**PROPOSED DEVELOPMENT OF ROYAL HEIGHTS, READING
DAYLIGHT & SUNLIGHT AMENITY AND GRANTLEY HEIGHTS – RESPONSE TO RESIDENT**

We have been instructed to respond to a query raised by a resident of Grantley Heights in terms of daylight and sunlight amenity. This letter serves as an addendum to our full report entitled 'Royal Heights, Reading Daylight and Sunlight Report' dated September 2018.

Enclosure 1 – Mark up of Grantley Heights from Local Resident

Extract 01 – Top Floor of Grantley Heights

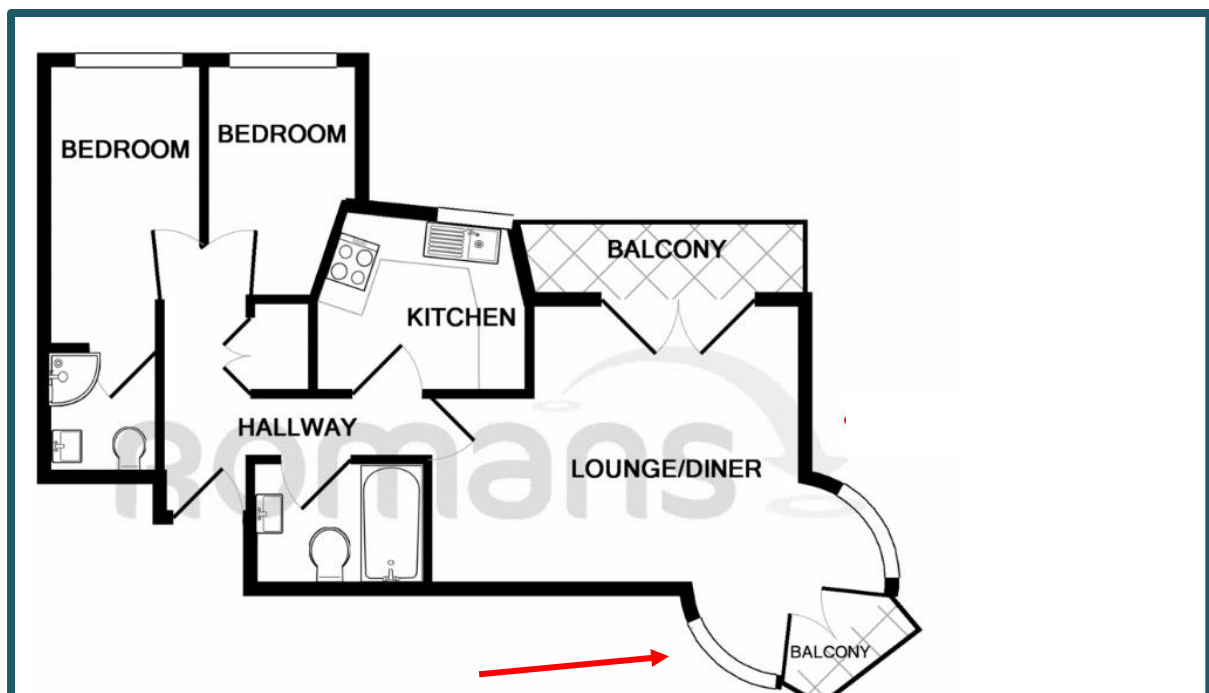
The person raising the query has not identified what these windows serve. We have tried to research this and have managed to locate a floor plan from sales particulars.

These plans have been incorporated into our analysis to establish an accurate calculation of the NSL within the room, in addition to the VSC taken at the window. The window serving the master bedroom is referenced as W2/105 in our results table enclosed hereto. In accordance with BRE Guidance, the bathroom does not need to be assessed.

The bedroom window receives a 35.79% VSC in the existing scenario, experiences a 37.94% reduction from existing vs proposed scenario and subsequently retains an absolute VSC of 22.21%. Turning to the NSL assessment within the room, there is an 8.9% reduction as a result of the scheme which the BRE Guide would stipulate to be unnoticeable.

In demining the overall significance of this impact one should consider, (1) the window receives an unusually high level of existing VSC (particularly in a urban area such as this), (2) the retained VSC is commensurate, if not better than, residential windows in a urban grain, (3) the reduction in NSL is unnoticeable, and, (4) the room in question is a bedroom which BRE Guidance regards as 'less important'. With all this in mind we would conclude the overall reduction in daylight to this room is minor in nature and acceptable given the urban locality.

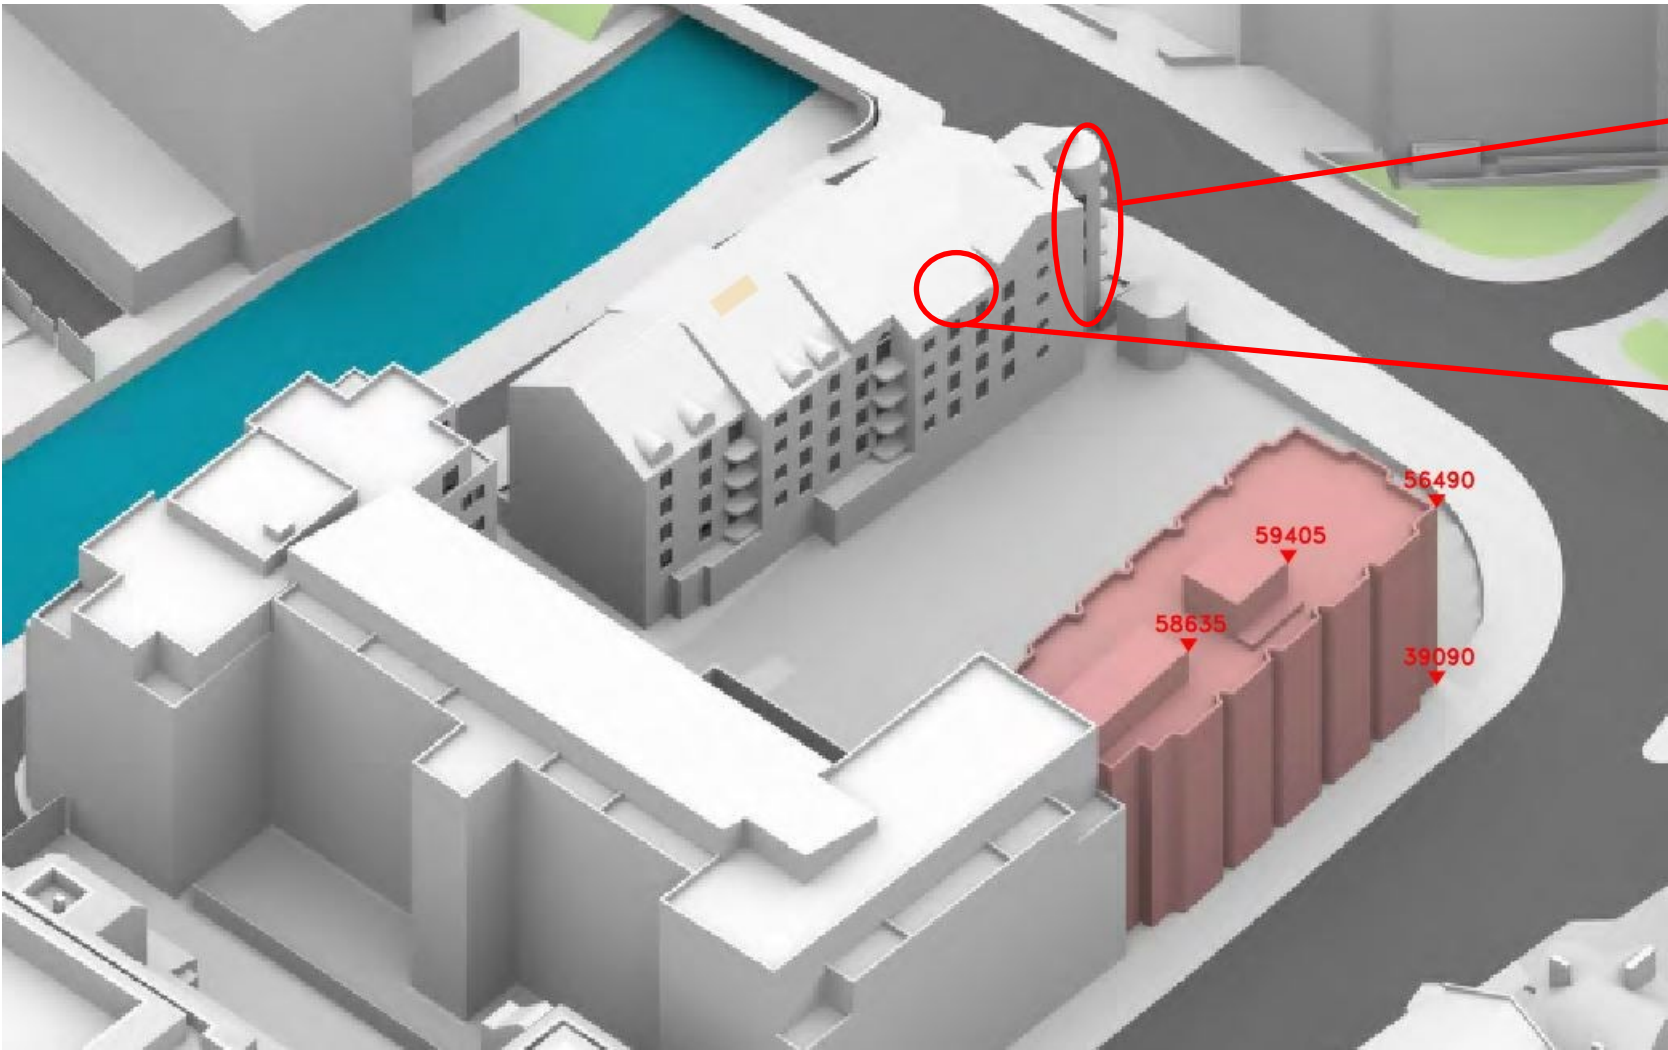
Grantley Heights Windows not included in Daylight/Sunlight Reports

None of these front room windows included in Sunlight/Daylight Reports.

These two windows missed off drawings, hence also not included in Sunlight Daylight Reports.

Point Surveyors Dwg No: P1624_02

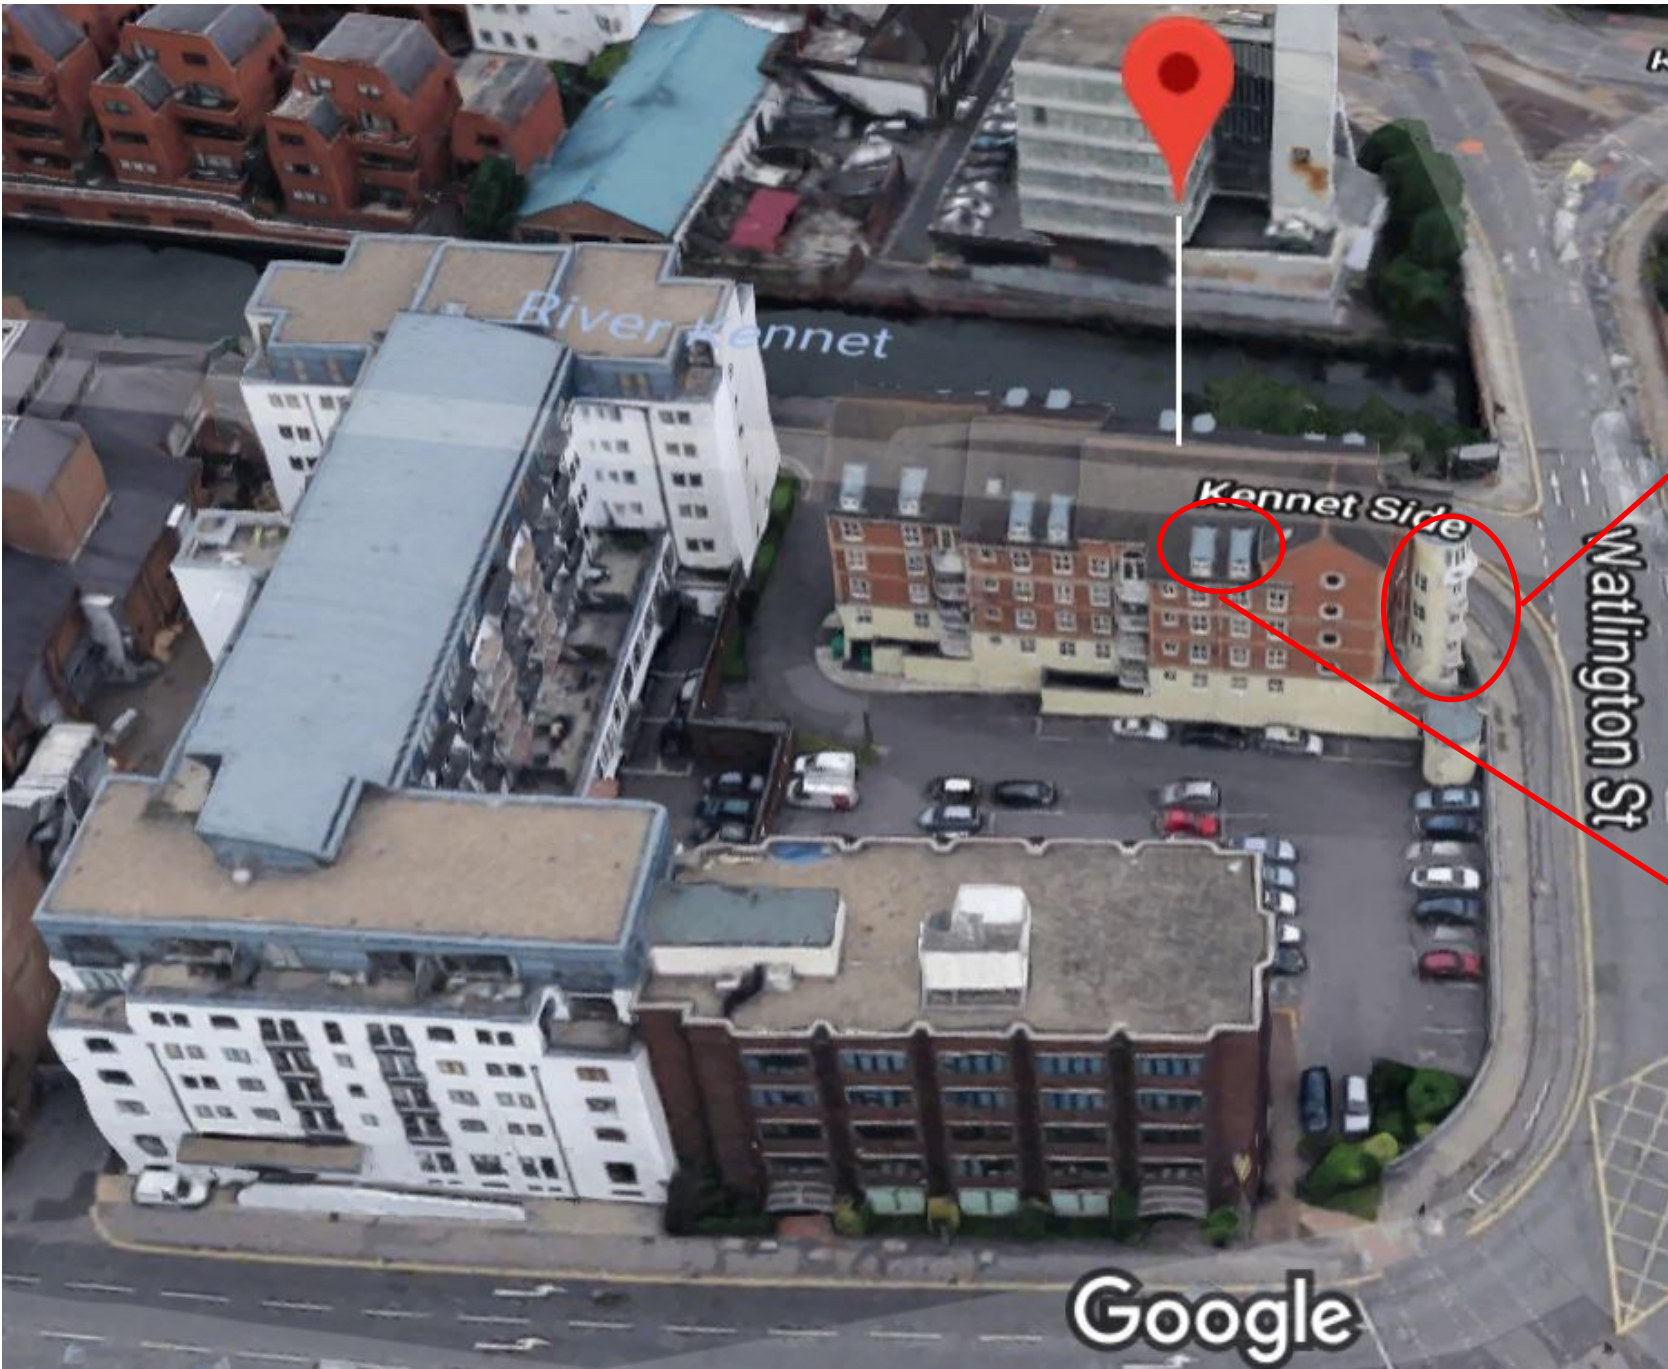
None of these front room windows included in Sunlight/Daylight Reports.

These two windows missed off drawings, hence also not included in Sunlight Daylight Reports.

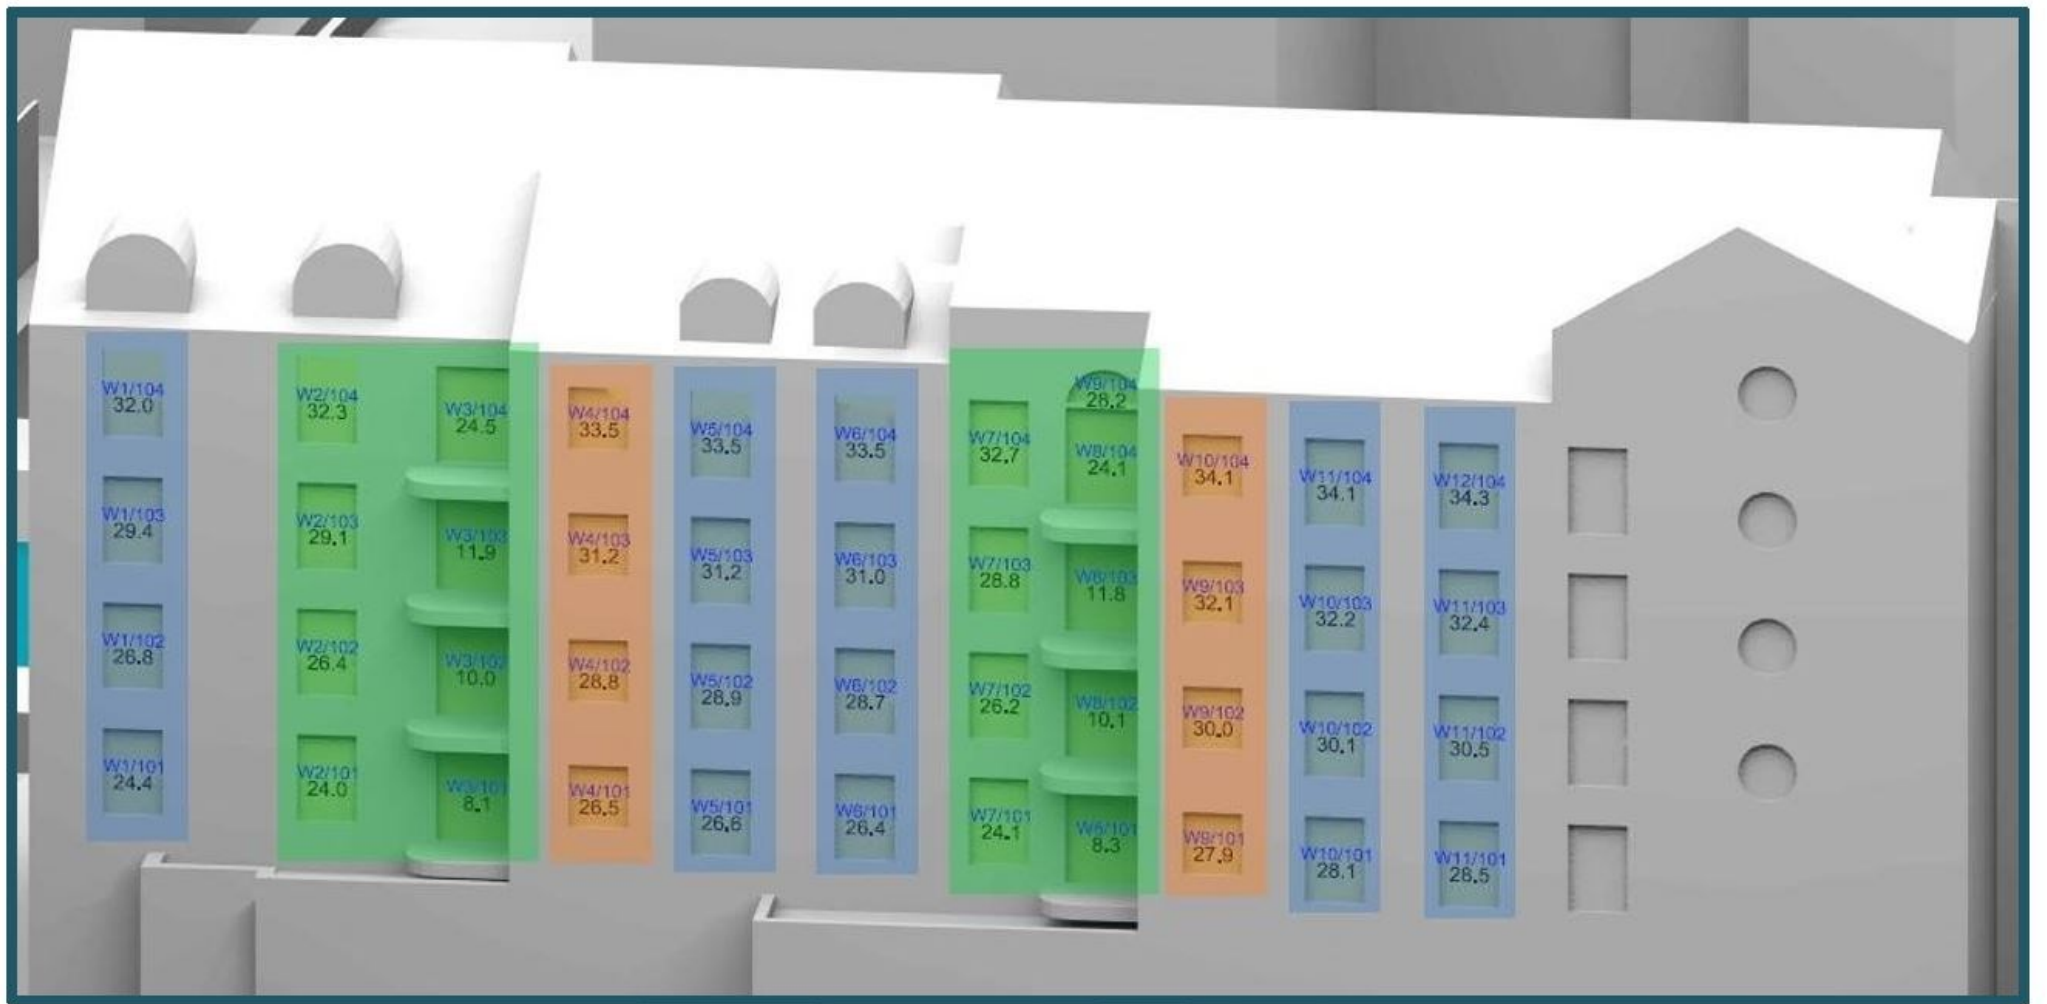
None of these front room windows included in Sunlight/Daylight Reports, but clearly shown in Mirror Massing Assessments.
